PE12-019

APPENDIX 11

2002-2004 Tribute Accelerator
Cable Recall 2704L

**2002-2004 Tribute
Accelerator Cable
Safety Recall [2704L]**

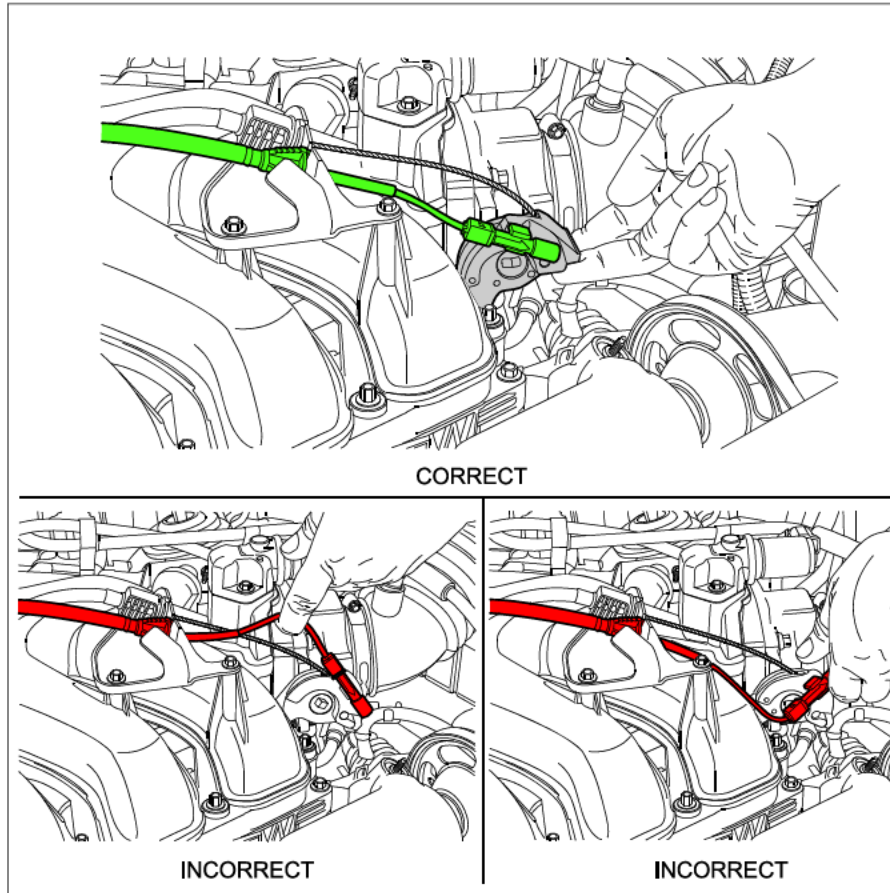
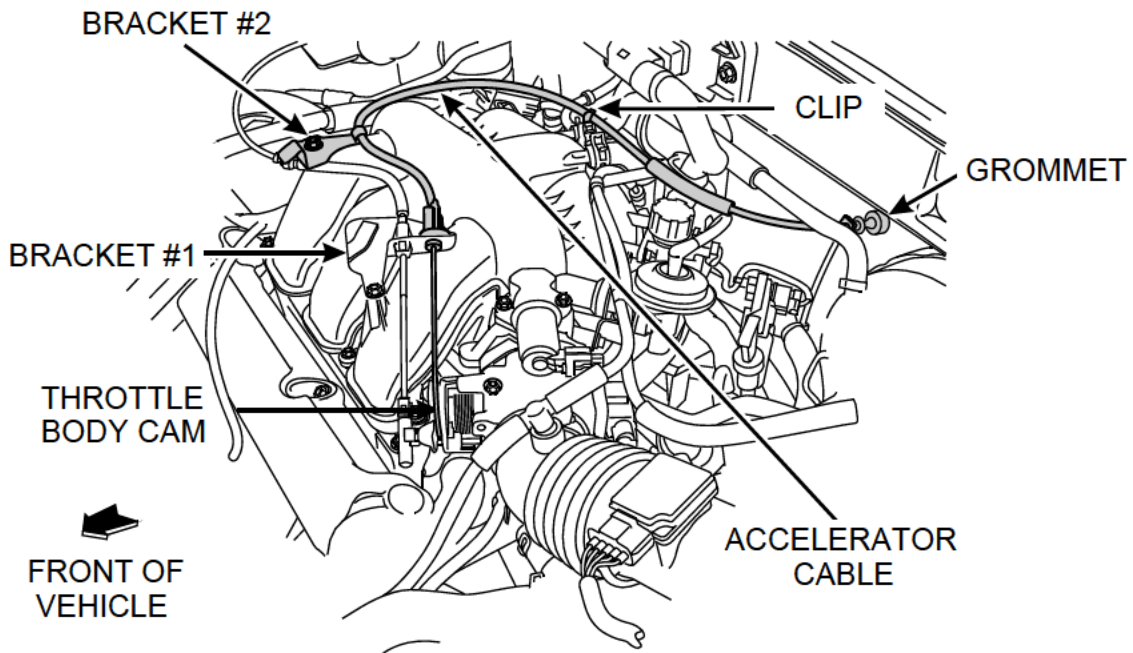
- A CAUTION has been added to the Repair Procedure on page 3 to help prevent damage to the speed control cable while performing the accelerator cable replacement procedure.

CAUTION: Damage to the speed control cable may result if the throttle body cam is rotated by lifting up on the speed control cable or the speed control cable connector end. When disconnecting the accelerator cable from the throttle body, rotate the throttle body cam only by lifting up on the cam itself. See Figure below.
